# Modification Recommended Service Note

## 11713E Attenuator / Switch Driver

Serial Numbers: MY60050108 to MY61410384

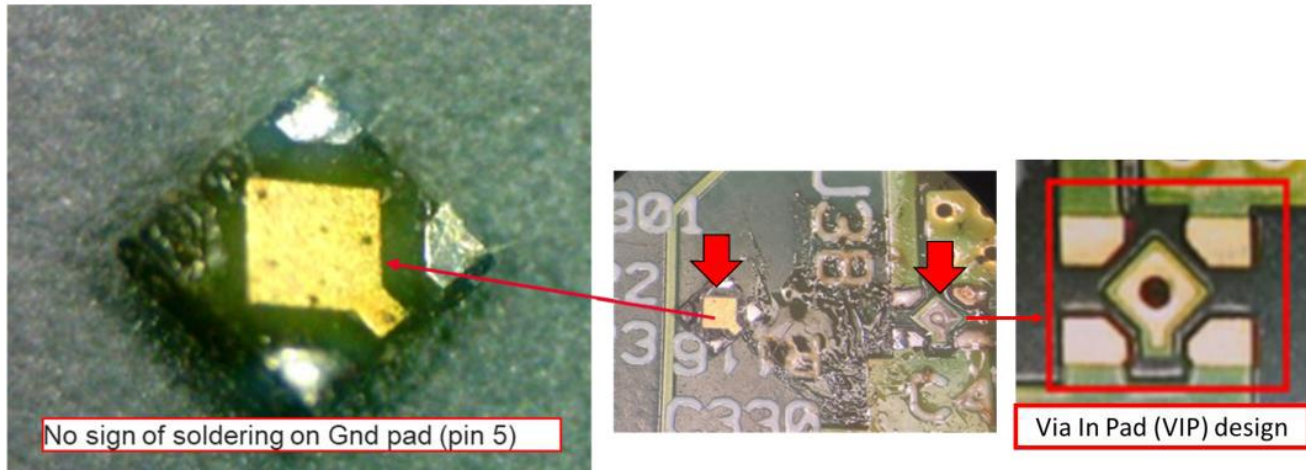
**The Problem** – There is a potential issue where some instruments are unable to boot up and are stuck on the boot-up screen. They are not functioning.

The instrument is unable to boot up and is stuck on the boot-up screen as follows. It is not functioning.

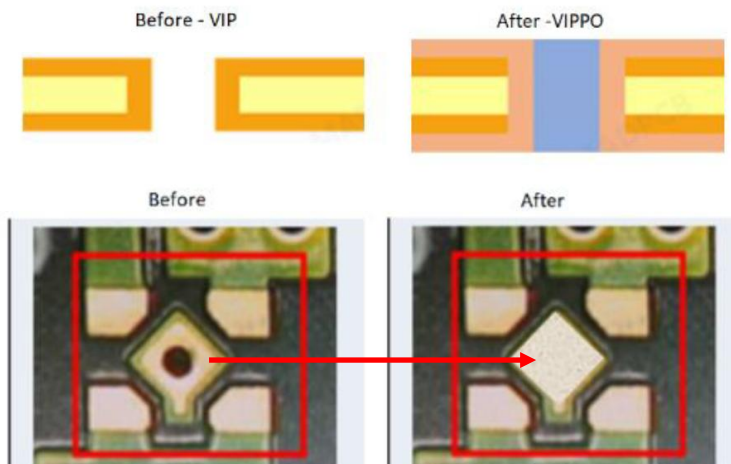
Failure analysis had indicated defective on P0600-63004 board where insufficient solder was observed at 2 locations. The insufficient solder was due to Via in Pad (VIP) where the melted solder had flown to the secondary side of the PCB.

The improvements were made from Via in Pad (VIP) to Via in Pad Plated Over (VIPPO) as per below.

Replace PPMC board P0600-63004 with Programmed PPMC board serial number P06006300423**2413**000007 onwards where 13 is the work week and 24 is the year.
